DEVELOPMENT APPLICATION ASSESSMENT REPORT

Application Number:	DA2022/1695	
Responsible Officer:	Megan Surtees	
Land to be developed (Address):	Lot 1 DP 5875, 385 Condamine Street ALLAMBIE HEIGHTS NSW 2100	
Proposed Development:	Alterations and additions to a dwelling house	
Zoning:	Warringah LEP2011 - Land zoned R2 Low Density Residential	
Development Permissible:	Yes	
Existing Use Rights:	No	
Consent Authority:	Northern Beaches Council	
Land and Environment Court Action:	: No	
Owner:	Jody Peter Wall Gemma Elizabeth Sandach	
Applicant:	Your Style Designer Home Additions	
Application Lodged:	18/10/2022	
Integrated Development:	No	
Designated Development:	No	
State Reporting Category:	Residential - Alterations and additions	
Notified:	24/10/2022 to 07/11/2022	
Advertised:	Not Advertised	
Submissions Received:	0	
Clause 4.6 Variation:	4.3 Height of buildings: 9%	
Recommendation:	Approval	
Estimated Cost of Works:	\$ 329,000.00

Image 1. Southern elevation envelope breach (indicated in yellow).

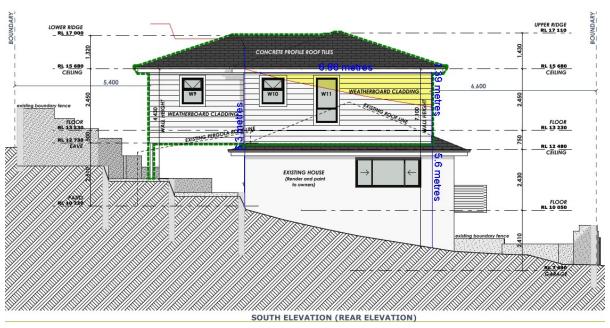
The proposed first floor addition encroaches beyond the boundary envelope for a portion of the southern elevation, as indicated in the image below.

This control permits an exception where the addition of a second storey to an existing dwelling house that, to a minor extent, does not comply with the requirement of this control. As detailed above, the extent of encroachment is considered minor and, therefore, the exception can be applied. It is noted that the subject site is irregularly shaped and has 3 street frontages, limiting the position of building mass.
